Value Engineering Study

FINAL REPORT

Widening of Parkway Extension
KY 9009, Campton to Salyersville
Wolfe-Morgan-Magoffin Counties
Study Date: August 17-21, 1998

Kentucky Transportation Cabinet (KTC)
Frankfort, Kentucky

**BIFURCATED SECTIONS OF PREFERRED
ALTERNATIVE**

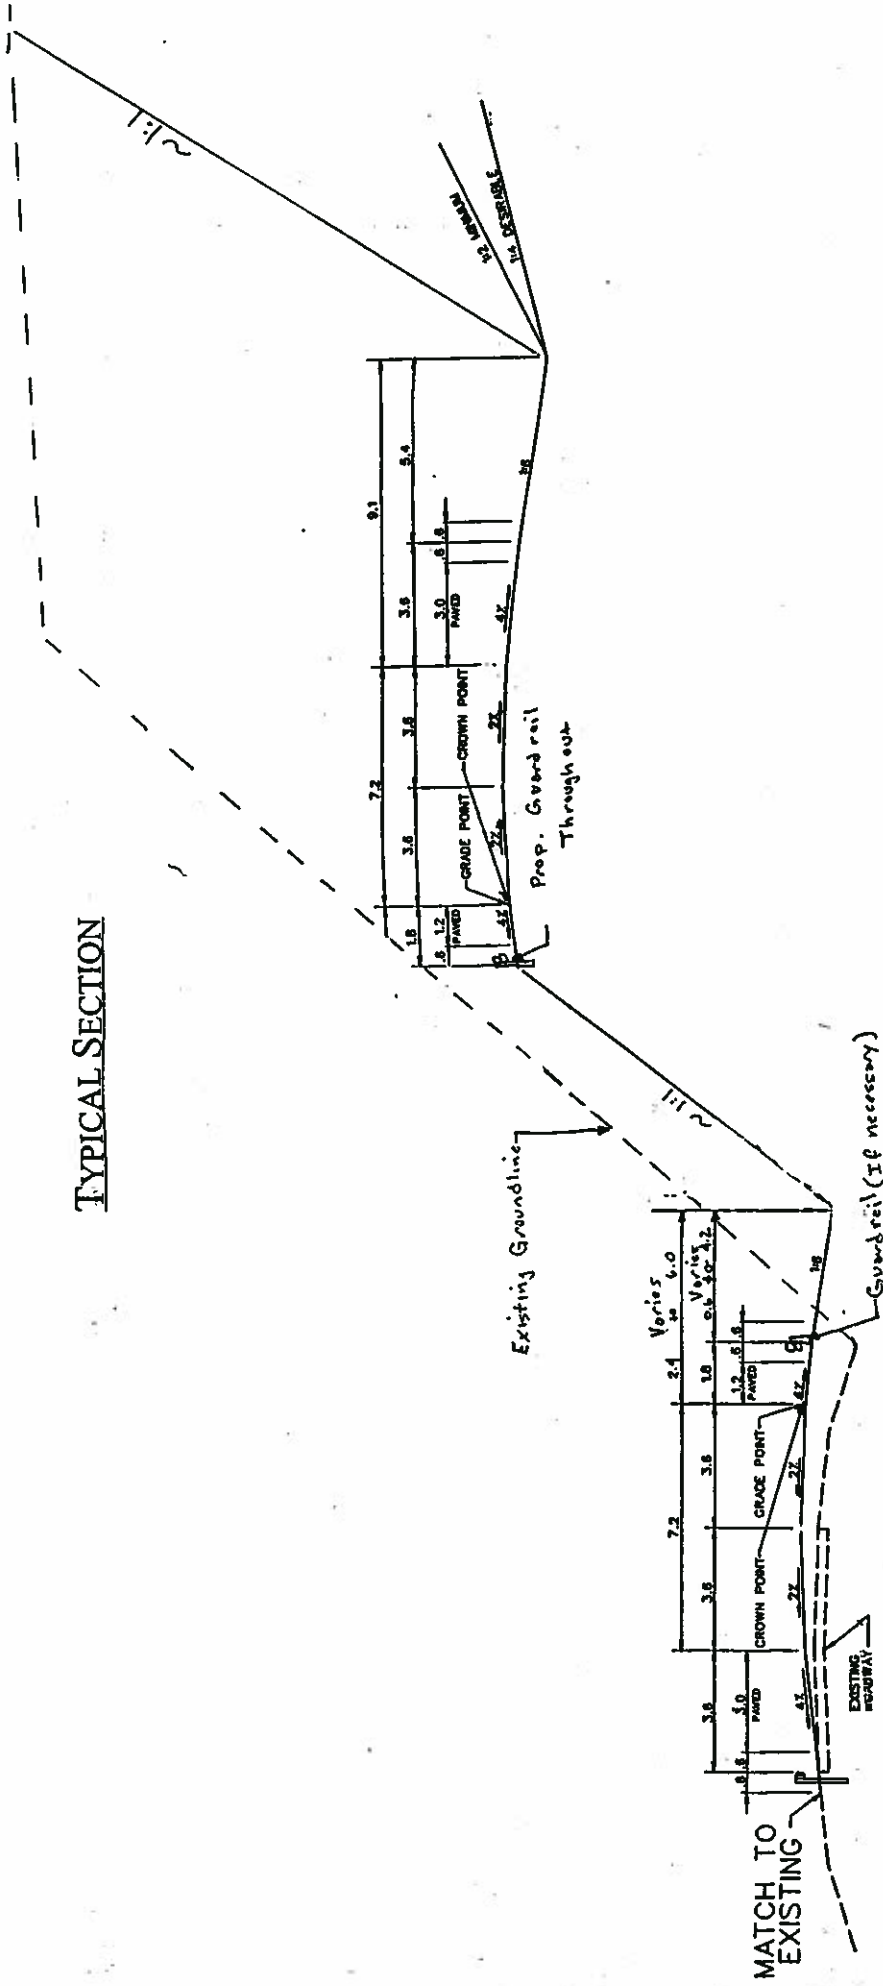
RECOMMENDED CHANGE: Bifurcation of the alignment for a limited section of the roadway. A separate line and grade will be required for each direction of traffic, in the bifurcated sections. This would allow one set of lanes to be higher and thereby reduce the amount of excavation. This procedure would not be practical throughout the whole project but where applicable, it could substantially reduce the overall project cost. Our recommended design proposed bifurcation of approximately 48% of the total alignment. Further detailed design studies may increase the length of the bifurcation and further reduce earthwork costs.

PERFERRED ALTERNATE
 ALIGNMENT'S SHIFTED SO EDGE OF PROPOSED DRIVING LANE IS AT EXISTING CROWN POINT.

EXHIBIT 7C
 BERT T. COMBS
 MOUNTAIN PARKWAY EXT.
 WOLFE/MORGAN/MAGOFFIN
 COUNTIES
STUDY ALIGNMENT
 Scale in feet
 Scale in millimeters

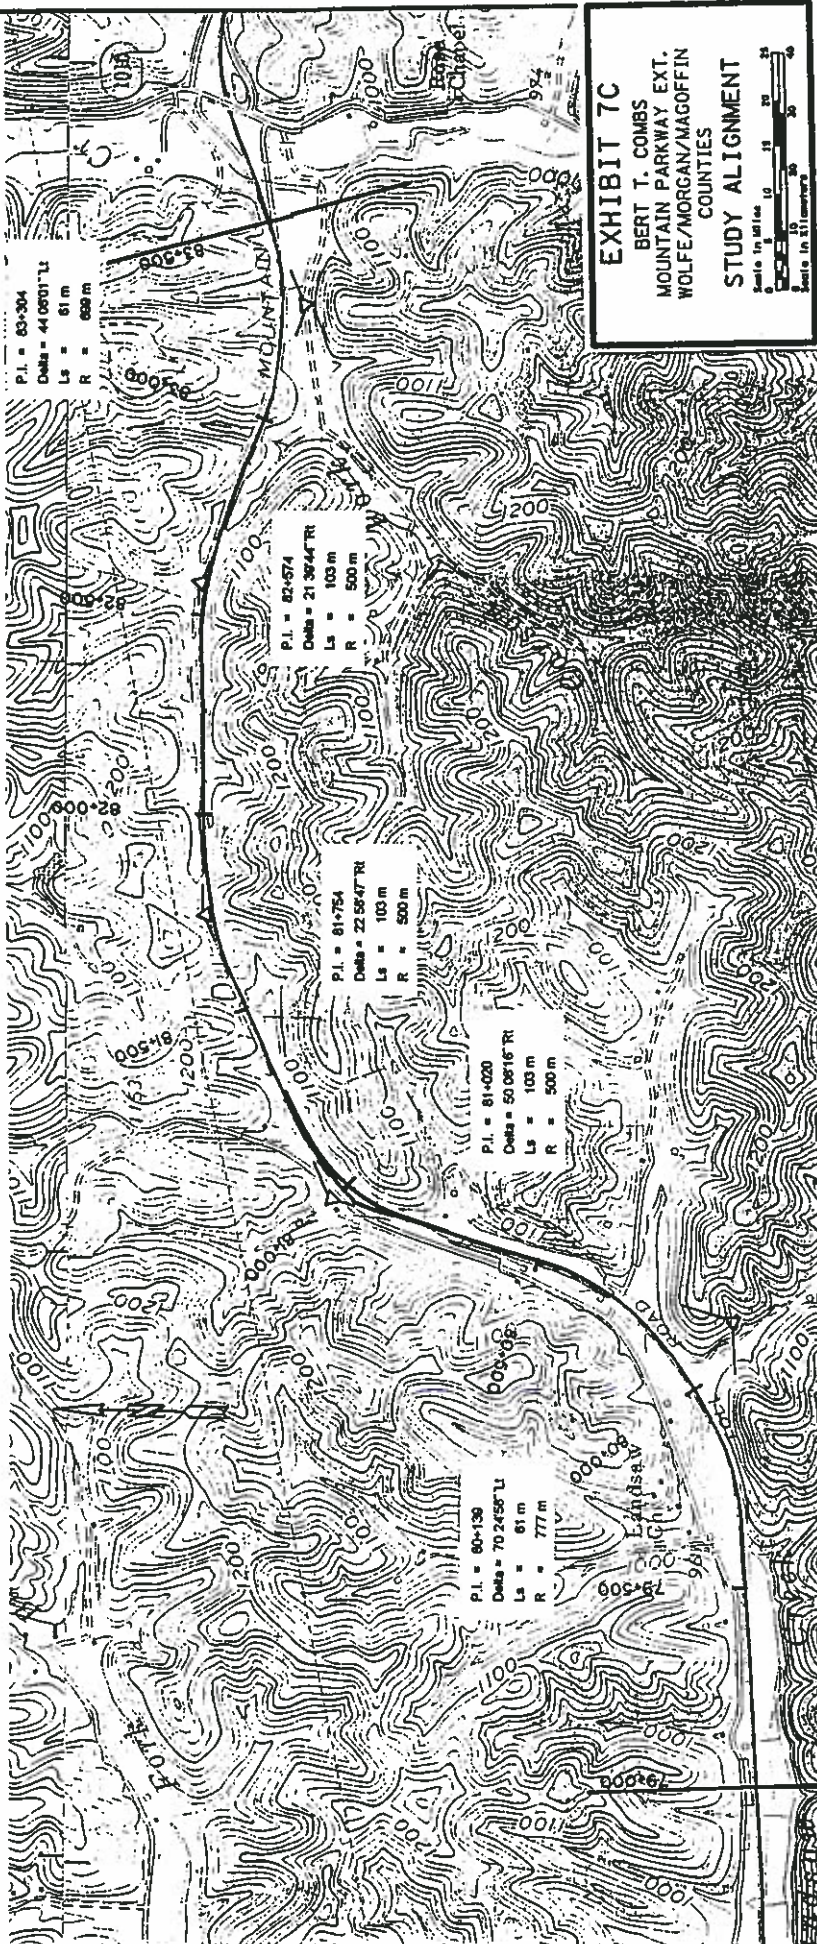
RECOMMENDED PROFILE MODIFICATION:
 RECOMMENDATION E-1

EXHIBIT 7K
BERT T. COMBS
MOUNTAIN PARKWAY EXT.
WOLFE/MORGAN/MAGOFFIN
COUNTIES
STUDY ALIGNMENT

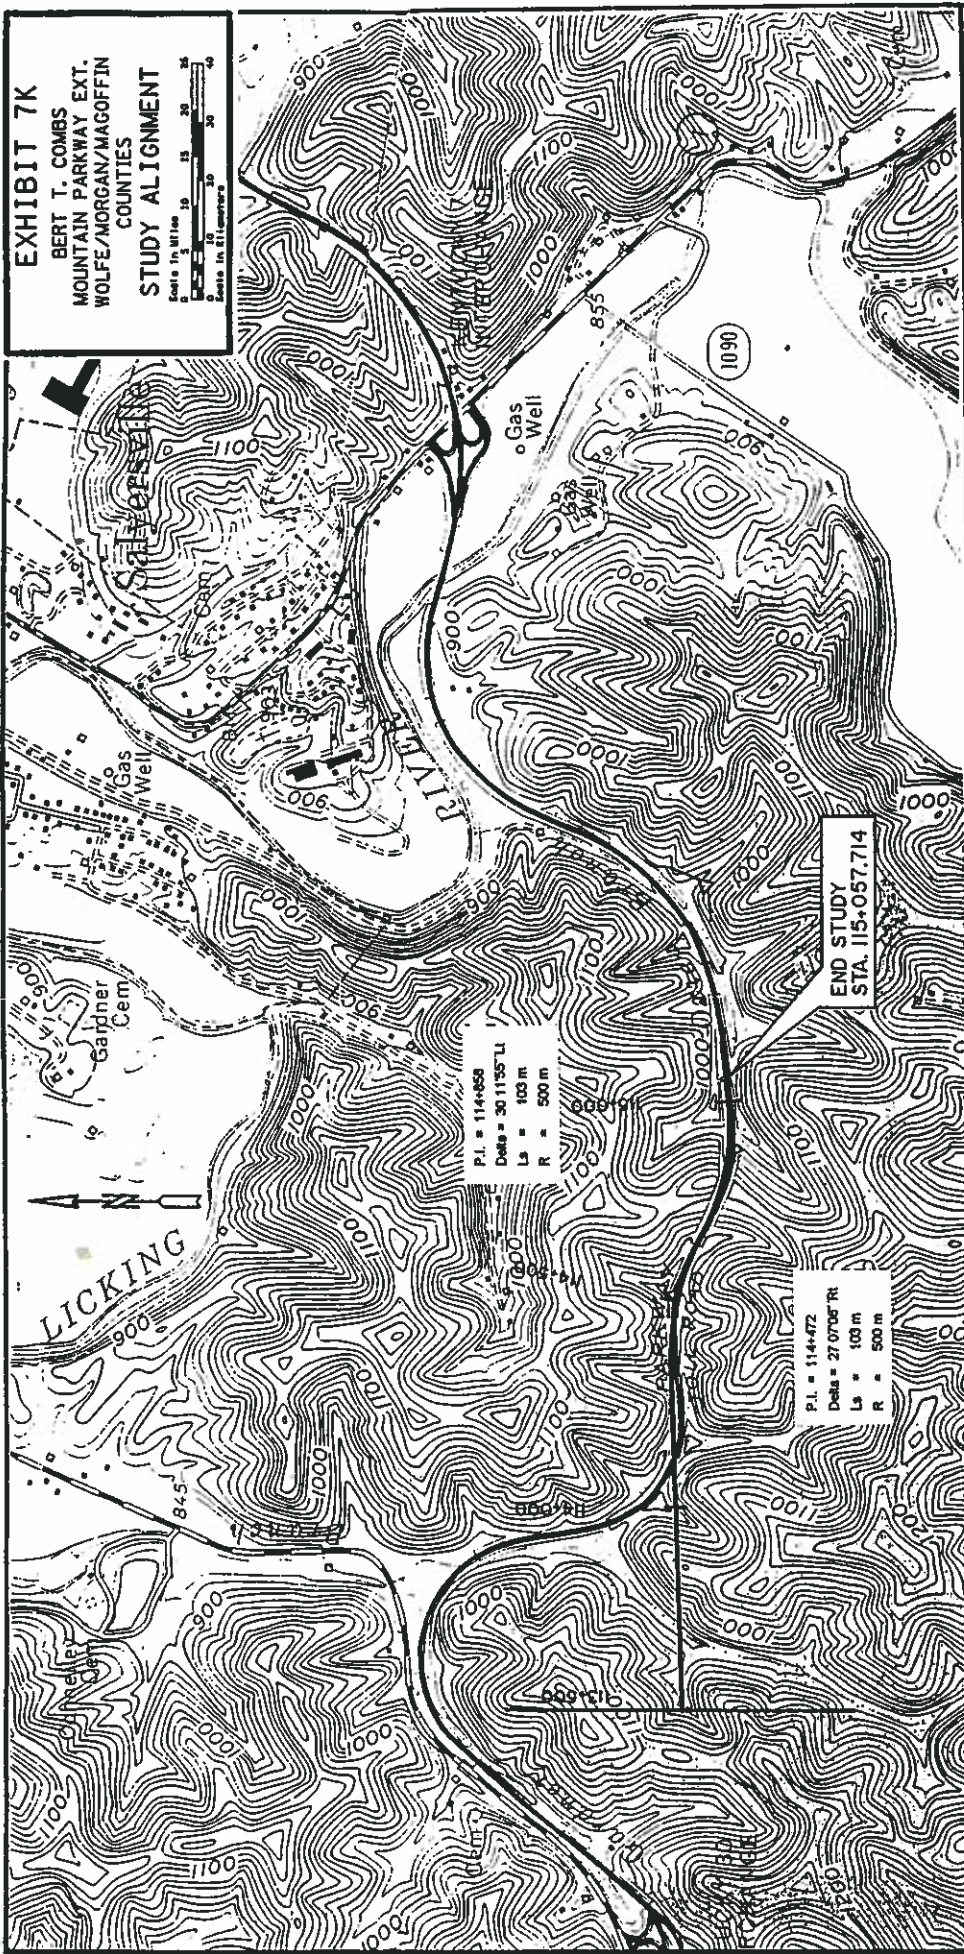
Bifurcation 21 (Station 113000 to 115000)

EXHIBIT 6C
BERT T. COMBS
MOUNTAIN PARKWAY EXT.
WOLFE/MORGAN/MAGOFFIN
COUNTIES
PROPOSED TYPICAL SECTIONS

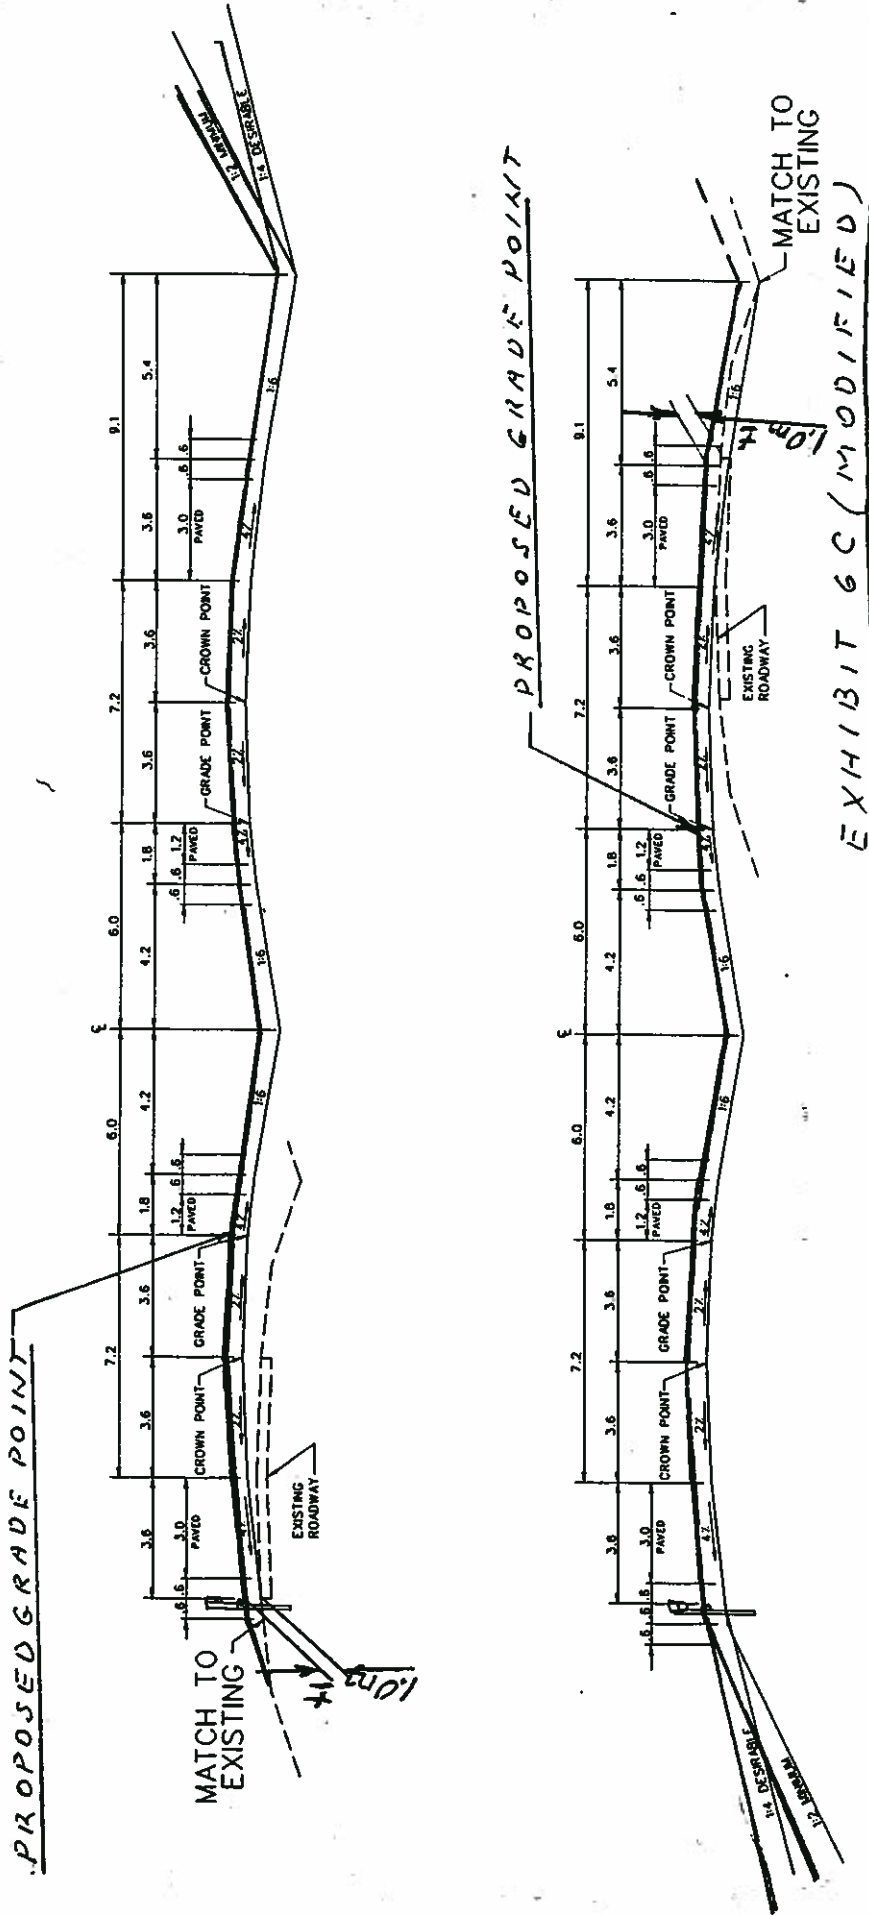
RECOMMENDED CHANGE: Raise the profile grade line by the thickness of the proposed pavement structure. The need for the removal of the existing pavement will be eliminated, and wasted material will be reduced.

VALUE ENGINEERING RECOMMENDATION G2

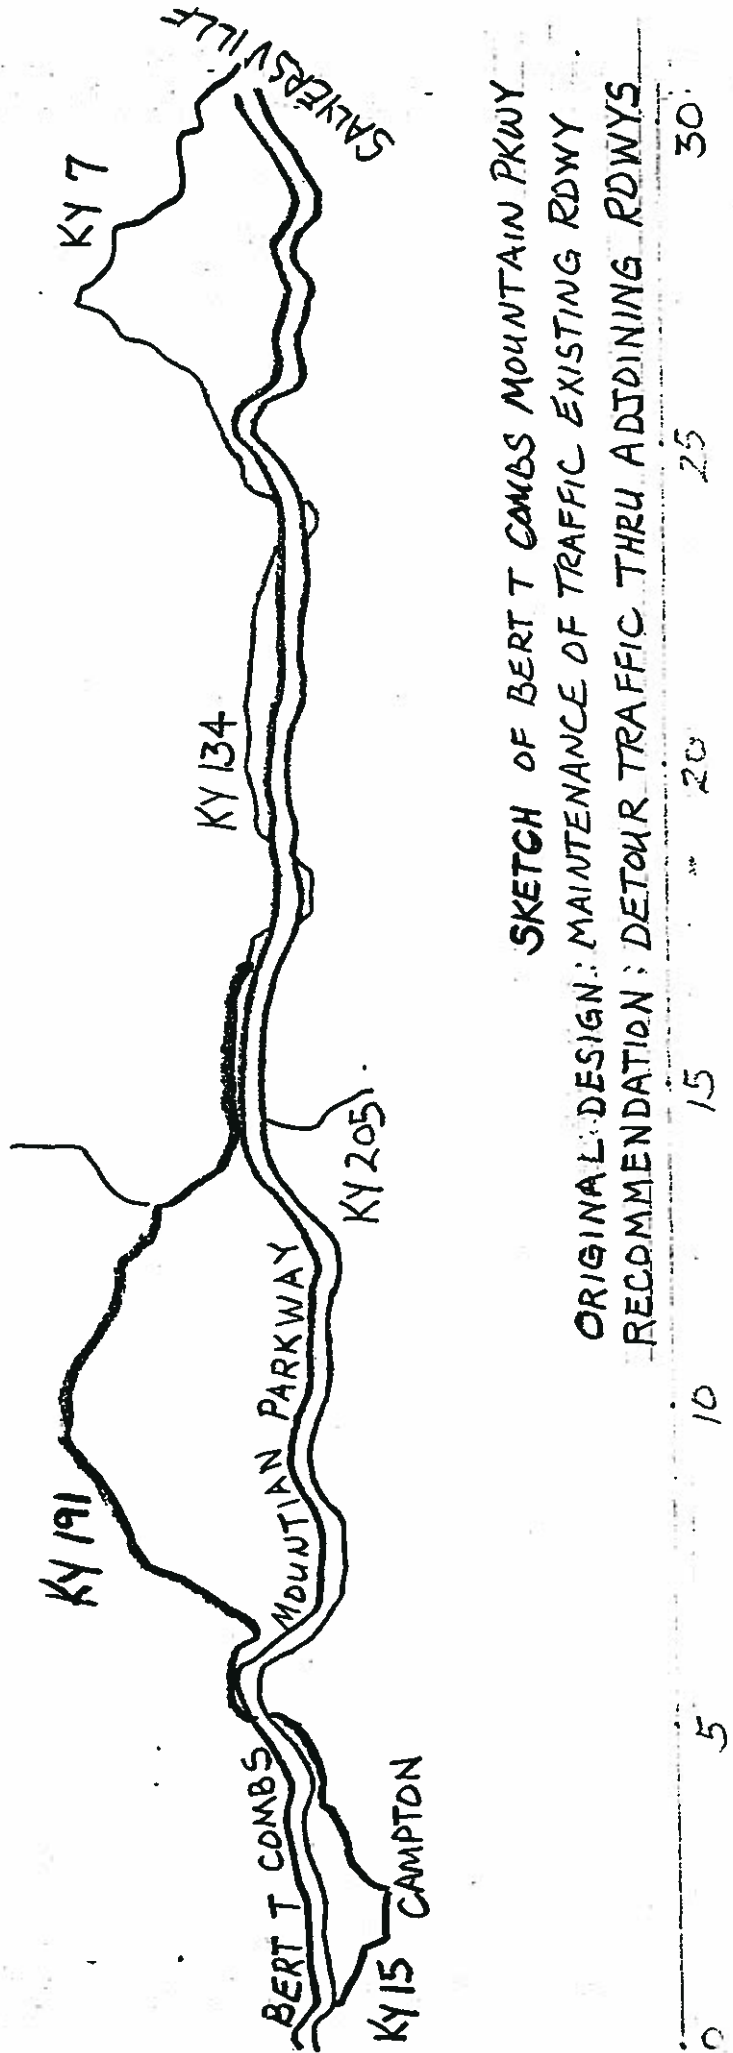
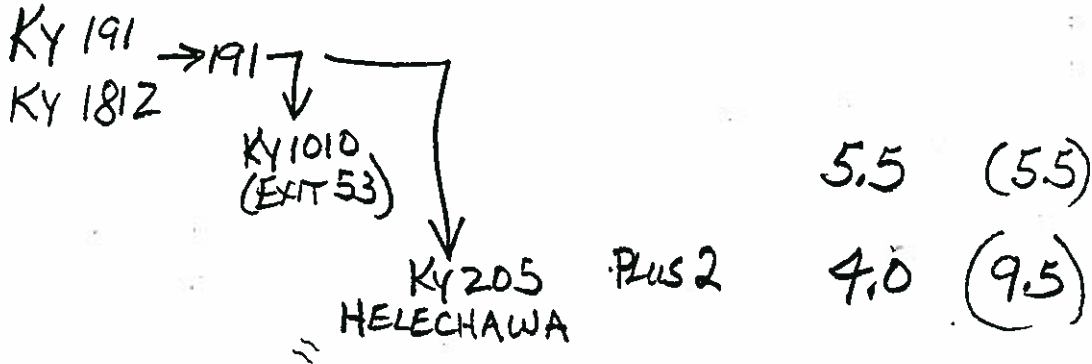
RECOMMENDED CHANGE: Completely remove the traffic from the construction area by utilizing the existing adjacent state roads. The proposed route could be divided up into six independent segments that could use local roads to tie into the proposed route and allow the public to travel safely away from the construction site.
